**ADDENDUM #1  
Parks and Open Space  
Restroom Construction at Lefthand Valley Grange Trailhead  
BID # 7163-20**

July 22, 2020

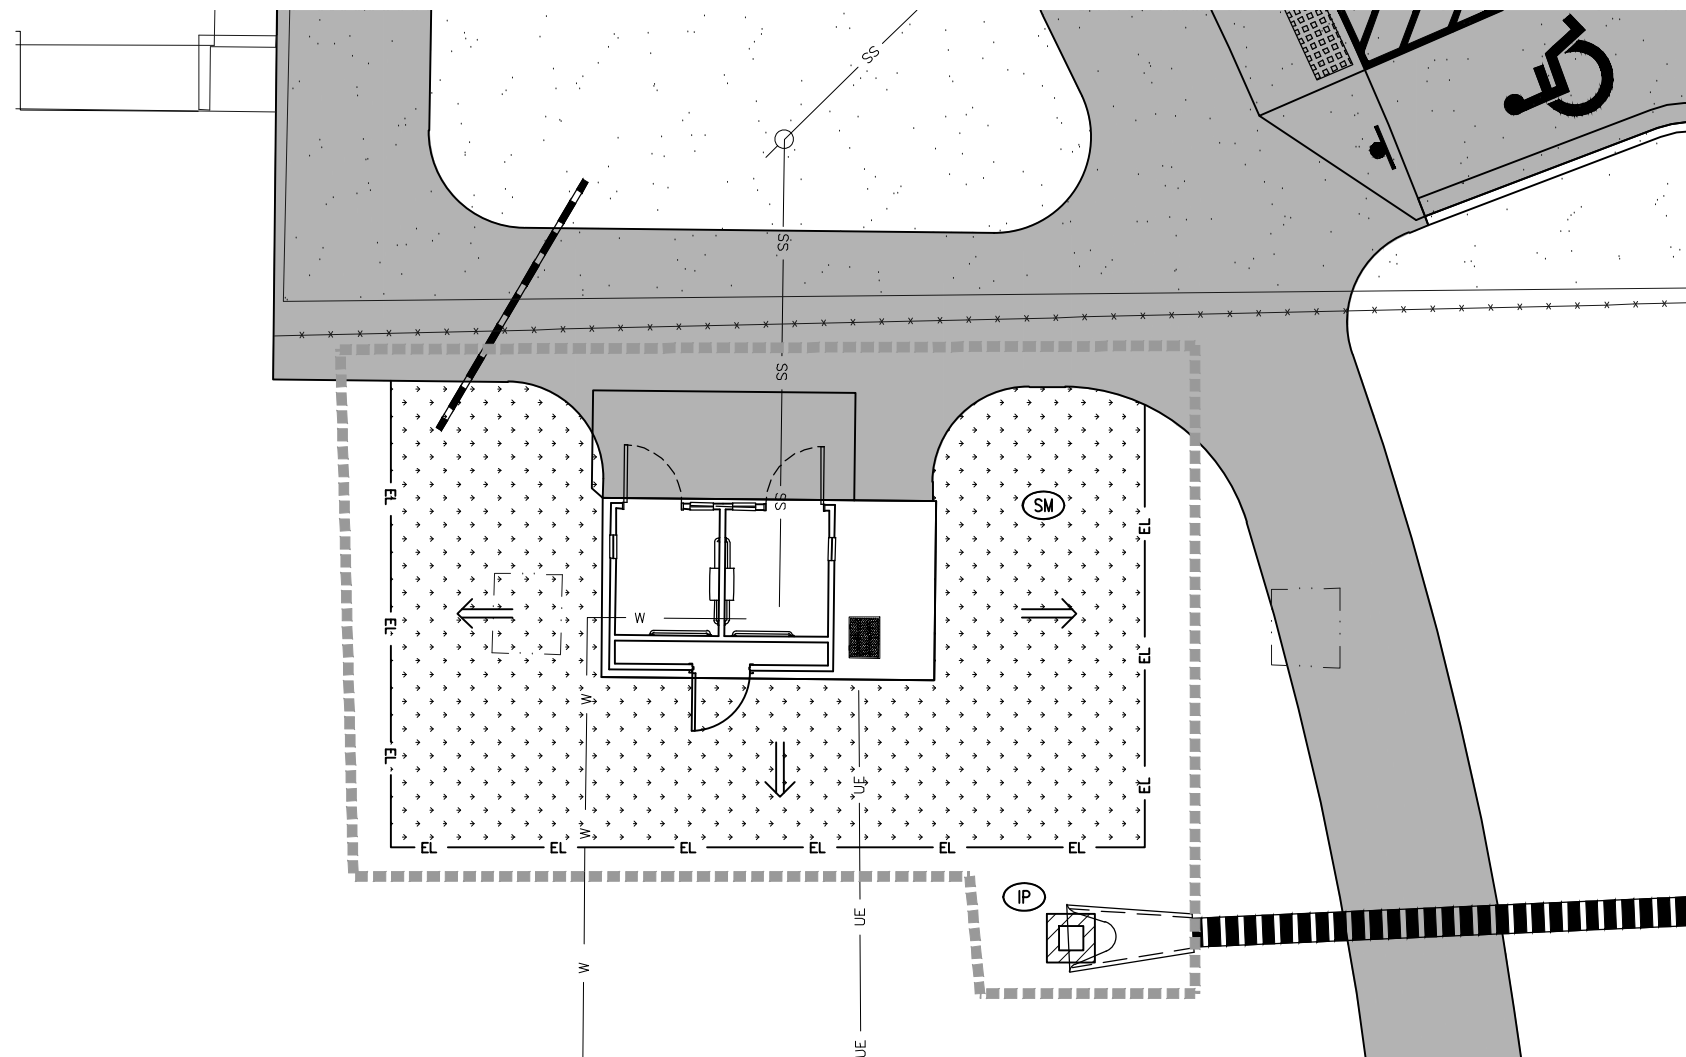
3. Question: Section 31 25 00, 1.1, C mentions an erosion control plan. We could not find an erosion control plan in the bid documents provide. Please provide.

**ANSWER: An erosion control plan is attached for your reference. The erosion control plan still needs to reviewed and approved by Boulder County Community Planning and Permitting to have a building permit issued. Once**

**approved, the selected contractor must follow all requirements and close out all required permits.**

**The restroom construction site is relatively small and very little disturbance is anticipated. The attached erosion control plan should meet all building permit requirements and we do not anticipate any major revisions.**
